DEVIATION REQUEST AND DECISION FORM

Project Name :	Skyline at Lorson Ranch
Schedule No.(s) :	5500000440, 5500000274, 5500000275, 5513300005, 5513310105
Legal Description :	See Attached

DEVIATION 1
EXHIBIT

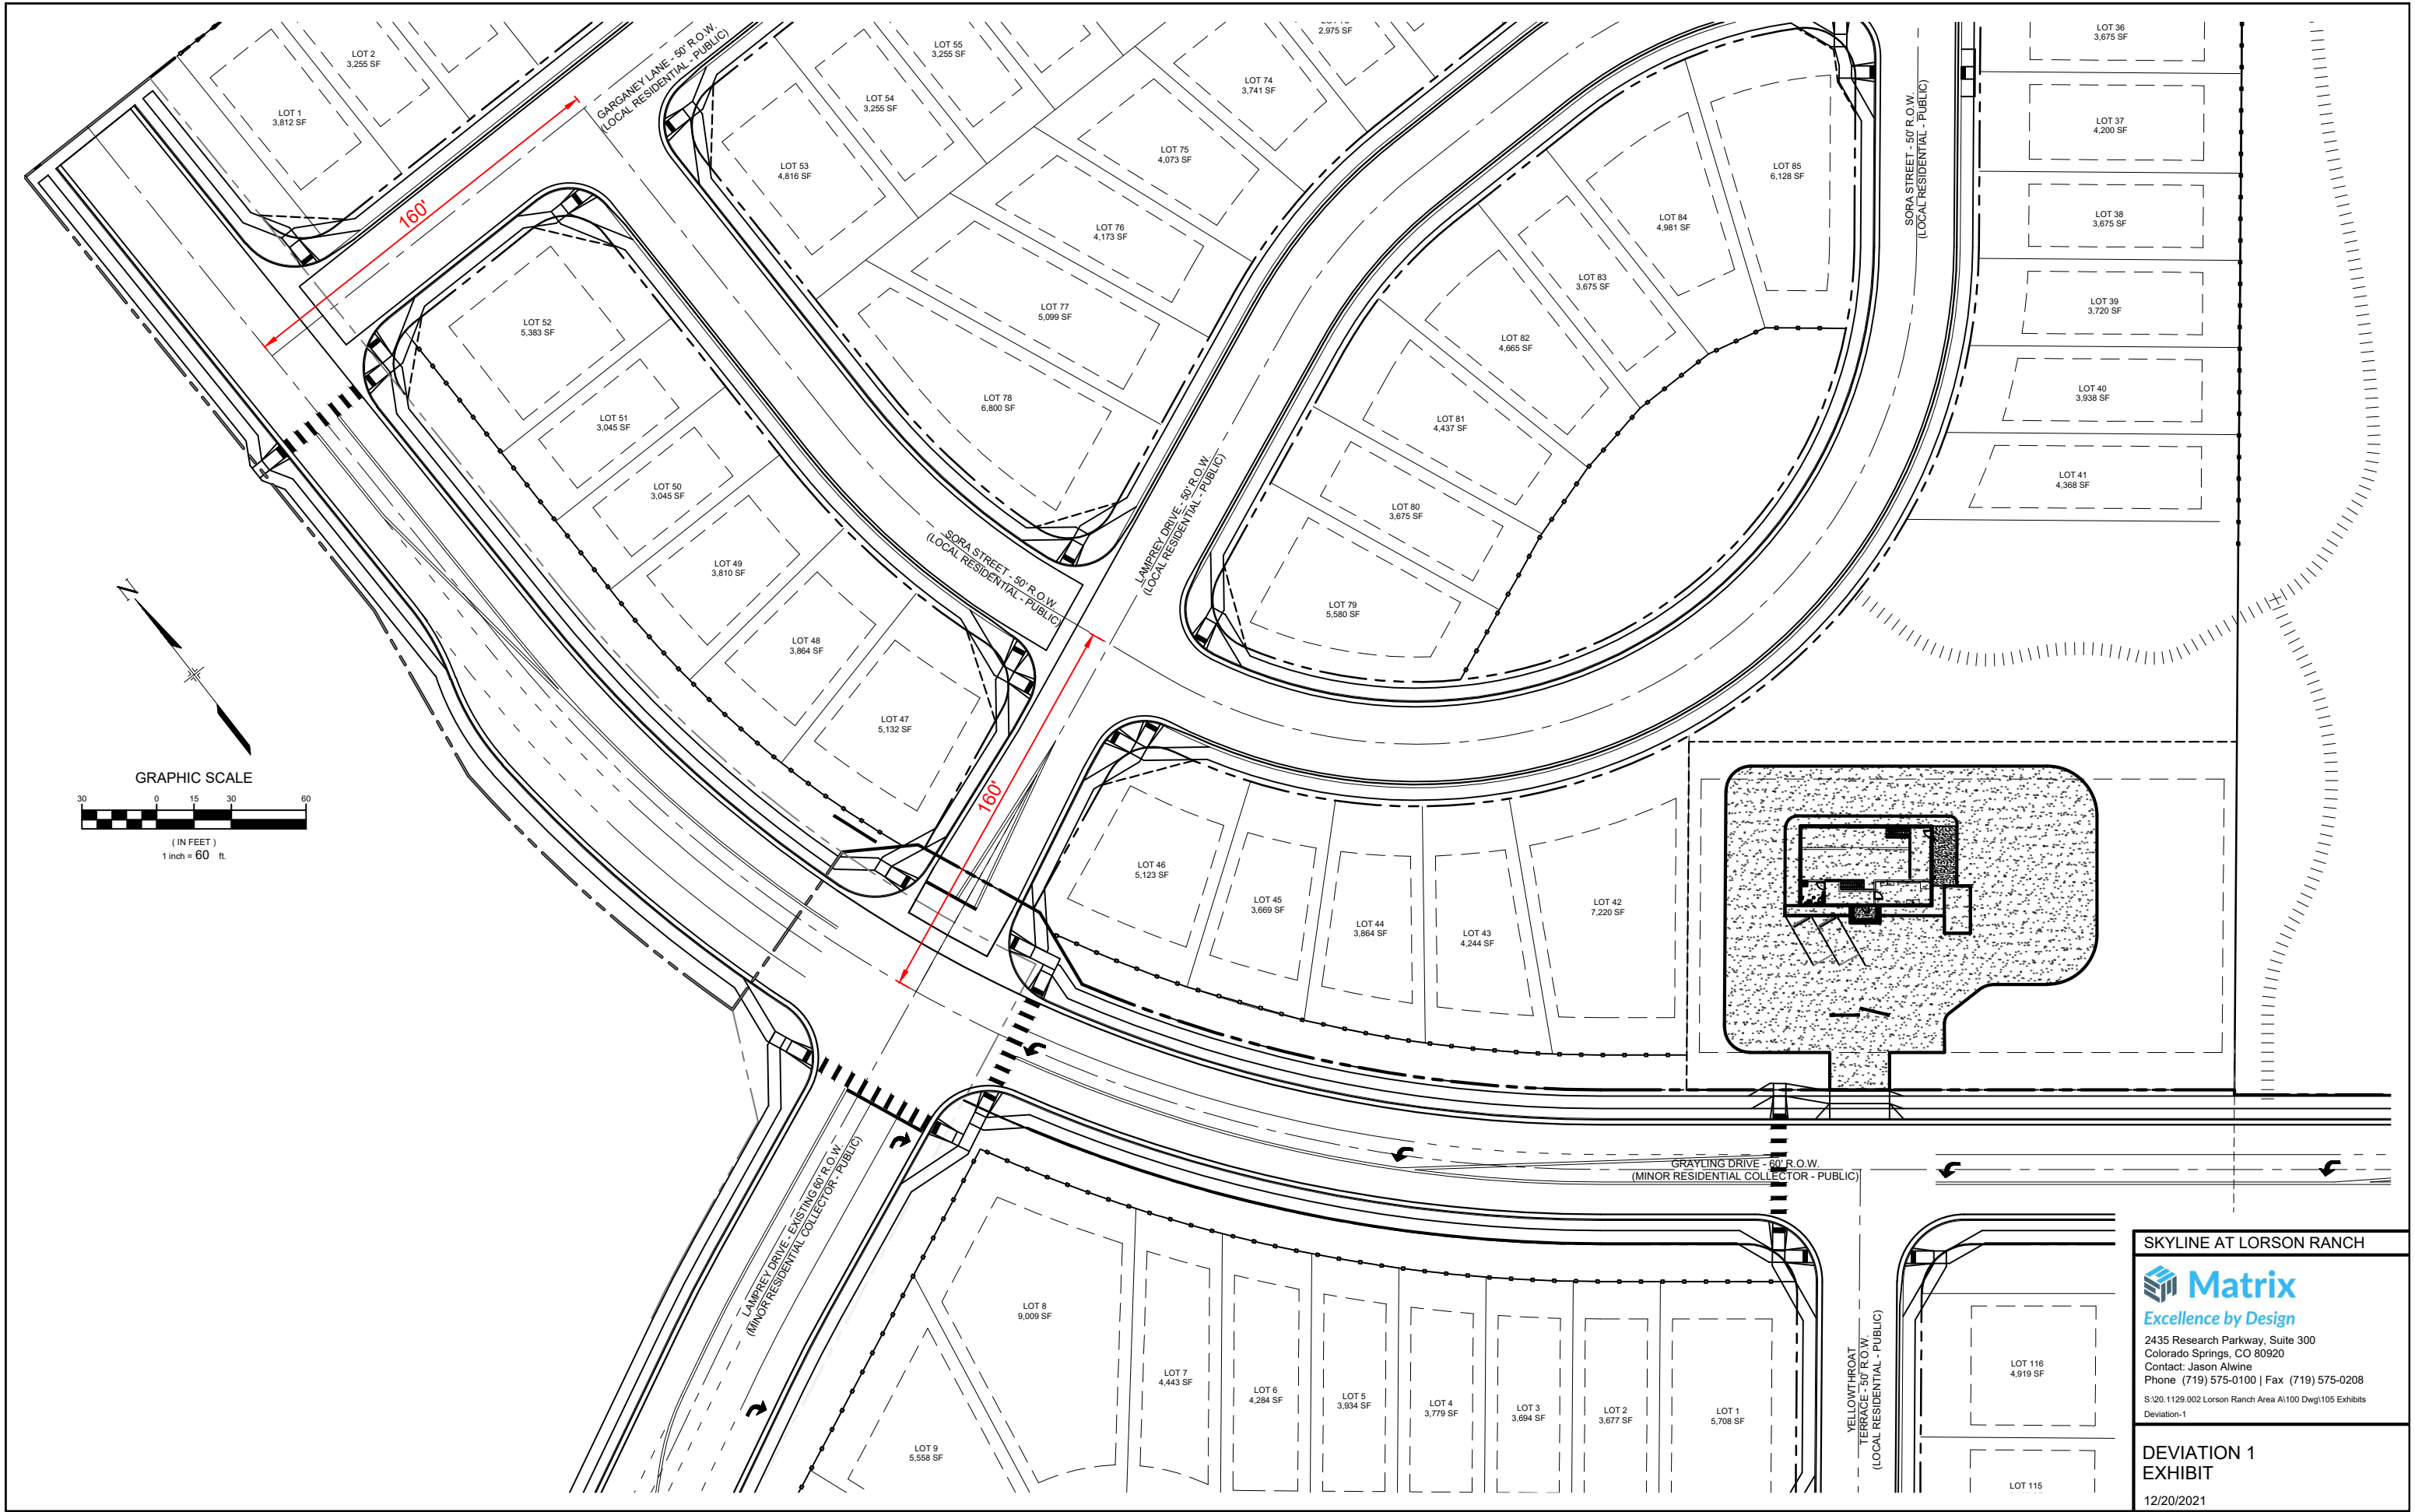
A deviation from the standards of or in Section 2.2.5 (E) of the Engineering Criteria Manual (ECM) is requested.

Road Access Criteria: On an urban local roadway, the closest intersection to a collector roadway shall be at least 200 feet (centerline to centerline).

To permit urban local roadways and a collector roadway to intersect centerline to centerline closer than 200'.

The proposed alternative to the ECM standard is requested because of a desire by the owner/ developer to provide smaller lot sizes to meet current housing market demands. This recent shift in market demand towards smaller lots with more common open space results in intersections spaced less than the required 200'. The 200' spacing requirement of ECM did not consider these smaller lots. Applying this standard would prevent the use of the small lots illustrated with this PUDSP and would require much deeper lots or additional tracts behind the lots to accommodate the ECM standard. The intersection spacing as shown at the intersections of Garganey Lane & Grayling Drive and Lamprey Drive & Grayling Drive is 160' centerline to centerline.

Grayling Drive, the intersecting road, is proposed as a minor residential collector. Per the 200' spacing requirement, in order to meet the standard the lots would have to be 130' deep in this instance. This is also taking into account the increased landscape setback along Grayling Dr.

The modification to permit roadway intersections less than 200' will not adversely affect safety or operations as these intersections are not designed as through streets, limiting traffic to residents only. The intersection spacing as shown at the intersections of Garganey Lane & Grayling Drive and Lamprey Drive & Grayling Drive is 160' centerline to centerline. This includes increased landscape setbacks along Grayling Drive. Given the limited traffic and no cut through options, the shortened intersection spacing is not expected to cause any queuing constraints. In addition, pedestrian safety should not be comprised as any vehicle entering the site will have done so after a complete stop or near complete stop keeping speeds at a minimum when approach the intersection crossings.

This request has been determined to have met the criteria for approval. A deviation from Section 2.2.5.E of the ECM is hereby granted based on the justification provided.
